Kansas Department of Agriculture
 Division of Water Resources
CHANGE: P/U WORKSHEET

RE: Change the Place of Use, File Nos 23247

DWR FIELD OFFICE APPLICATION FOR APPROVAL TO CHANGE THE PLACE OF USE AND/OR THE POINT OF DIVERSION

GMD3 Change Review

Change in Place of Use: WR #23247

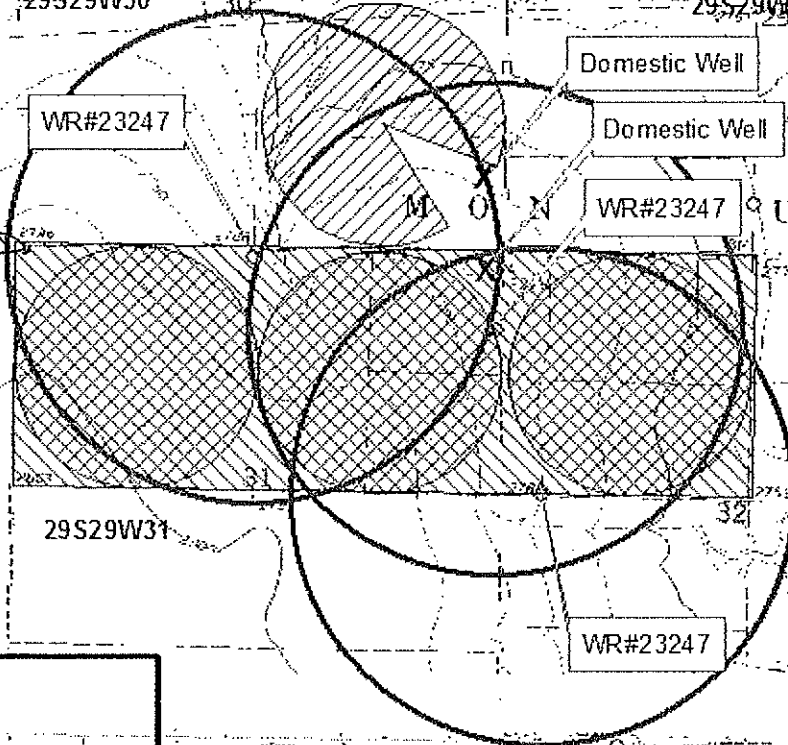
I agree to the best of my knowledge that all known water wells (IRR, DOM, IND, etc) are shown within green circles on map. If not, I have edited the map indicating the location of the well, type, & owner information.

Change in Place of Use WR #23247

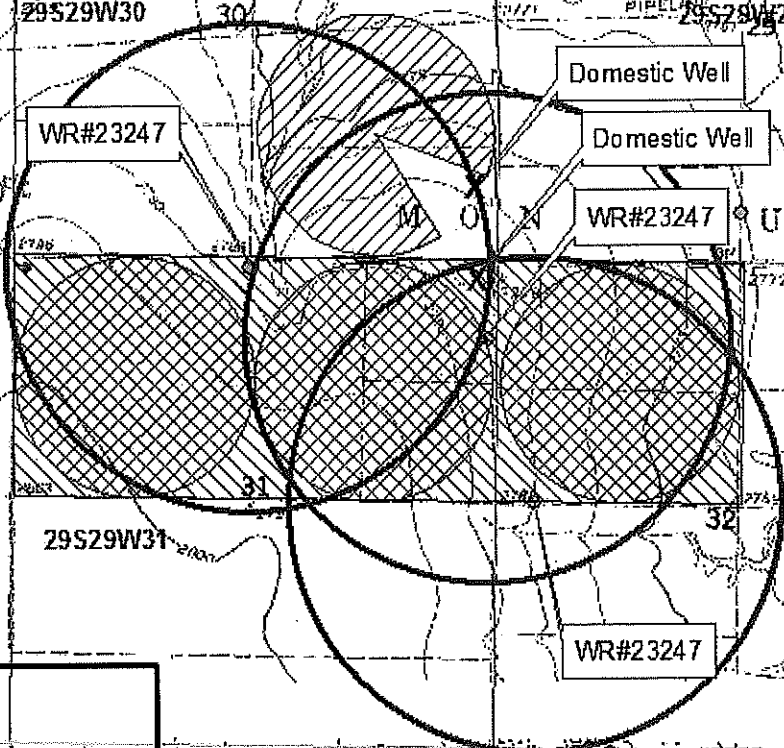
I agree to the best of my knowledge that all known water wells (IRR, DOM, IND, etc) are shown within green circles on map. If not, I have edited the map indicating the location of the well, type, & owner information.

23247 Change Review, PU

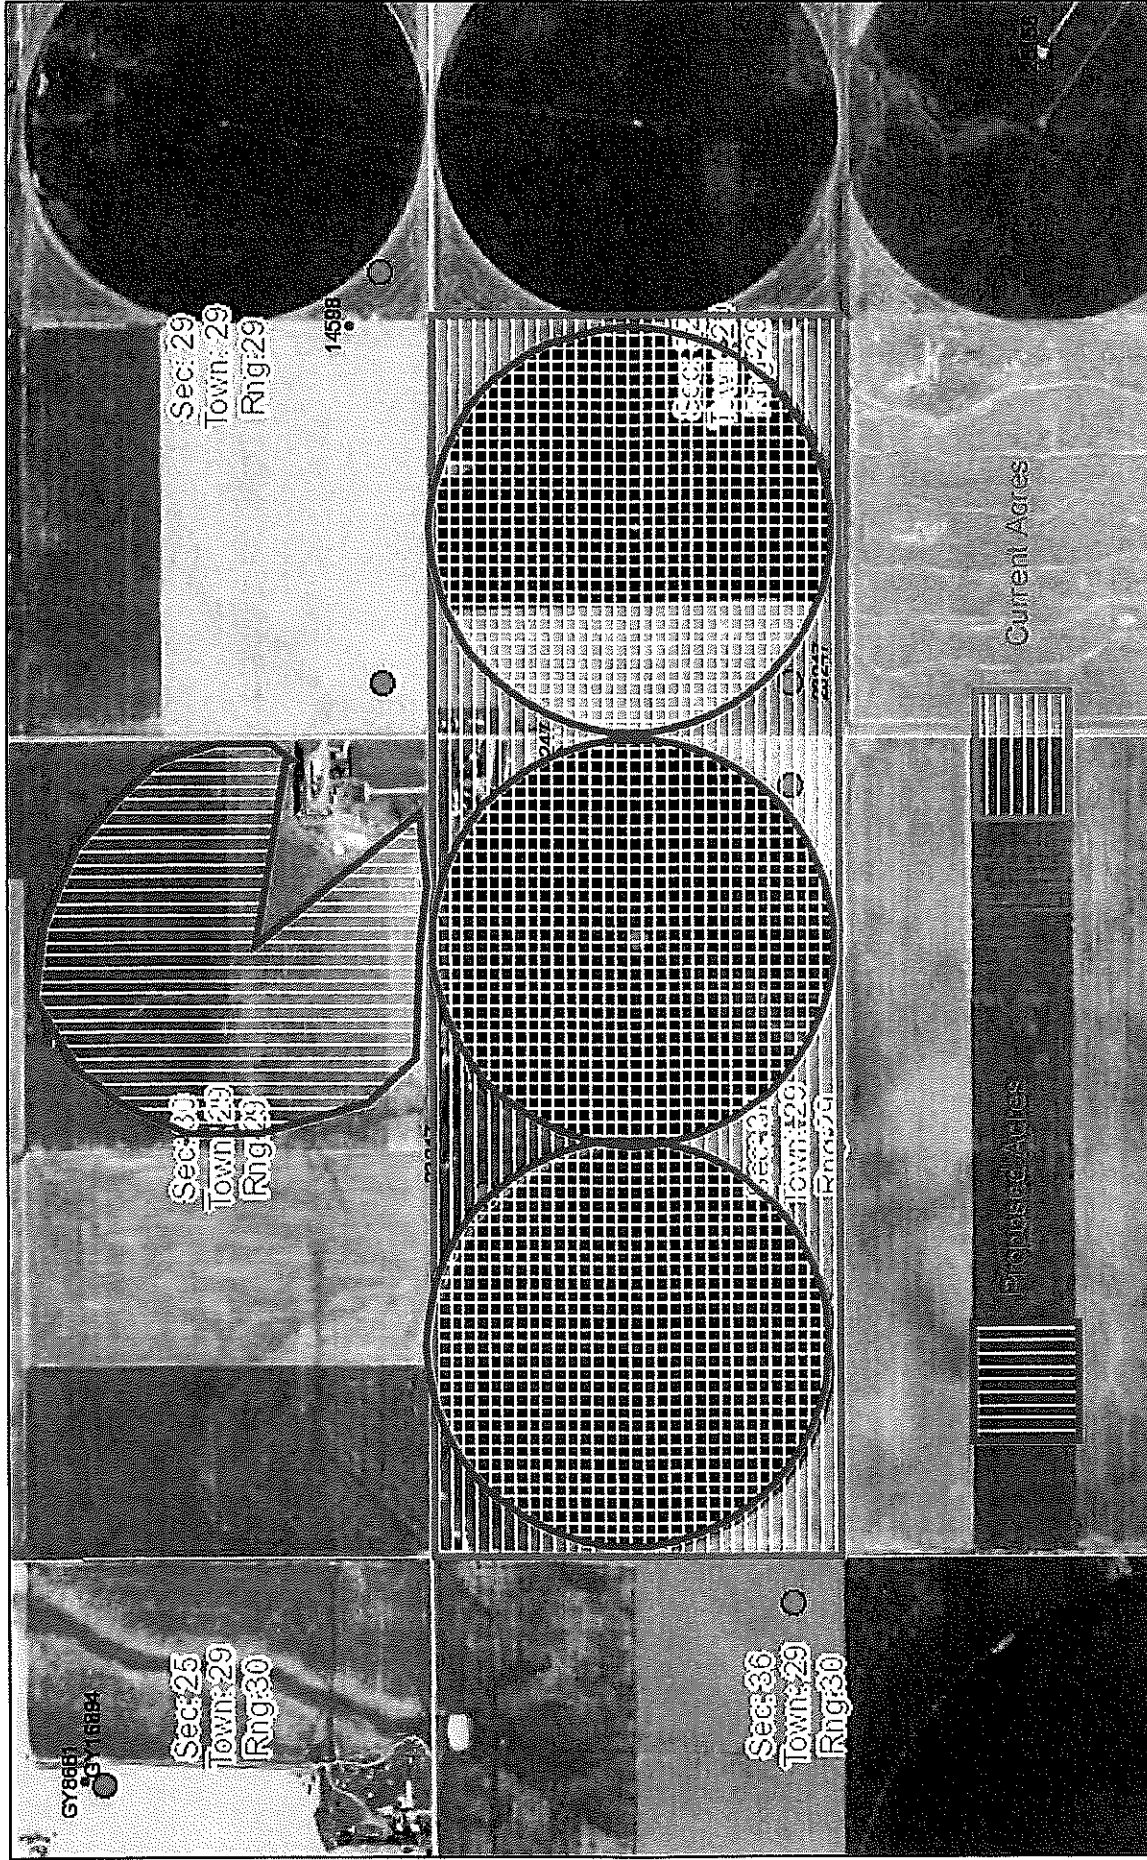
Is Proposed PU overlapping existing WRs? NO.

Current acres = 477.25

Proposed acres = 477.25

Applicant proposes eliminating the corners of pivots from three quarters in order to add a portion of a pivot on ground currently not authorized.

Final Recommendation: After review of all available information, it appears the current area rules are met. Staff therefore recommends approval of the application.
